RE: **SUPPLEMENT TO STAFF REPORT ISSUED ON JULY 19, 2012, REGARDING CIENEGA WATER COMPANY INC.'S – APPLICATIONS FOR A PERMANENT RATE INCREASE AND FINANCING APPROVAL (DOCKET NOS. W-02034A-11-0194 AND W-02034A-11-0195)**

**ARIZONA CORPORATION COMMISSION
STAFF'S SUPPLEMENT TO
THE STAFF REPORT ISSUED ON JULY 19, 2012
FOR
CIENEGA WATER COMPANY, INC.
DOCKET NOS. W-02034A-11-0194 & W-02034A-11-0195**

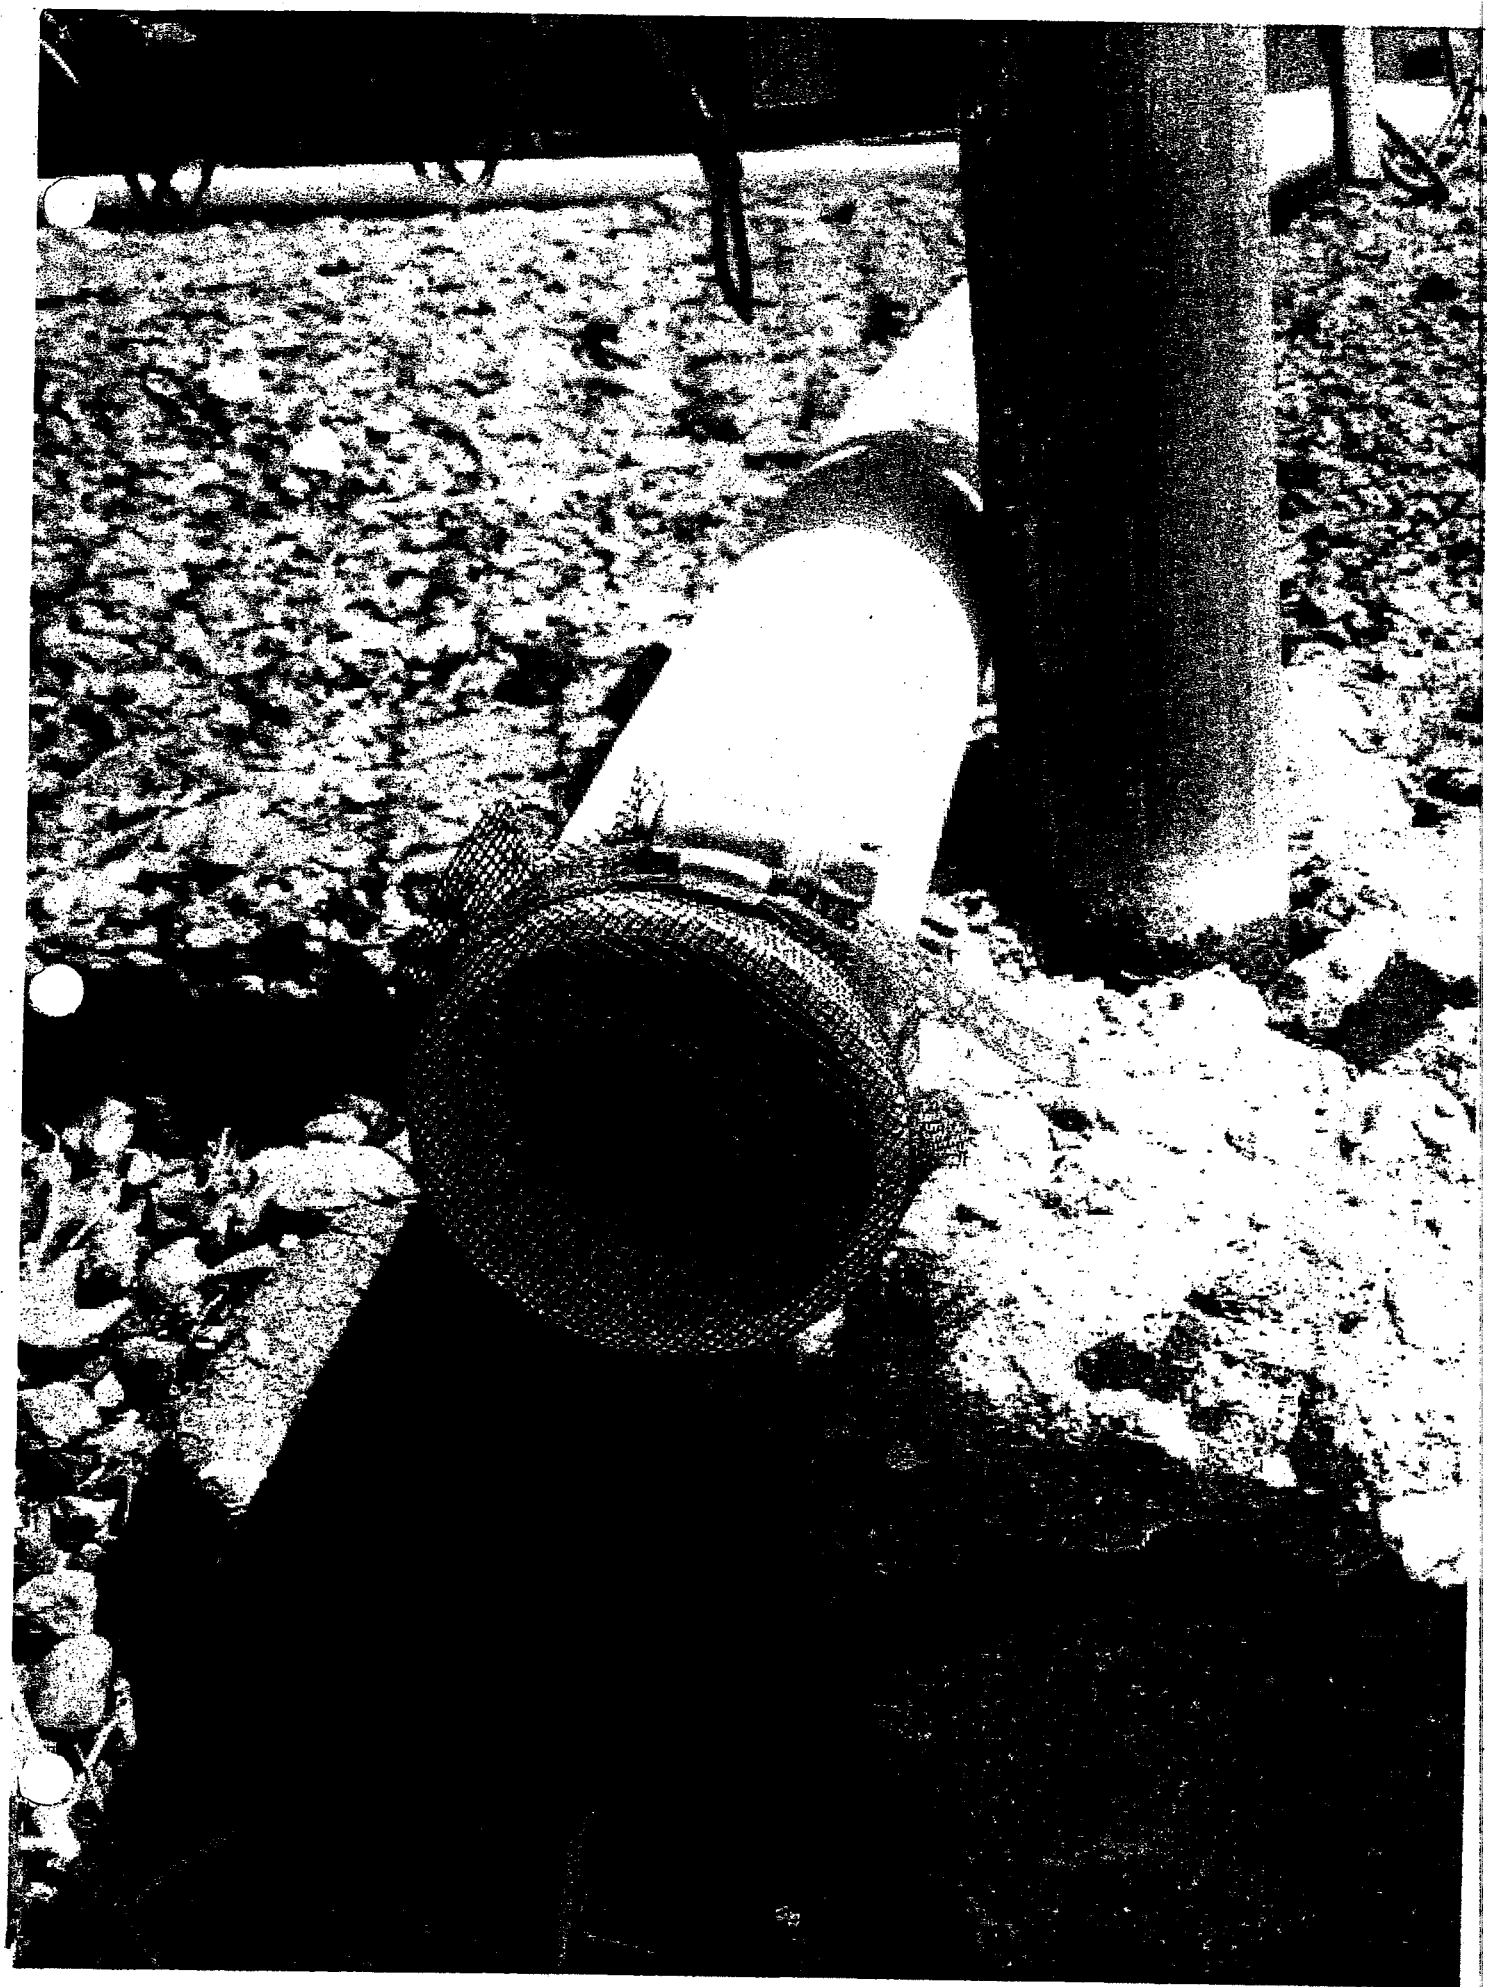
Debra also attached a picture of the screened overflow pipe and a picture showing the slab at well #2 has been sealed (see attachments).

1. Certification has been reinstated
2. Mesh screen was installed on overflow pipe
3. Cracks were sealed with silicon caulk around well.
4. Hose was removed and vacuum breaker was installed.
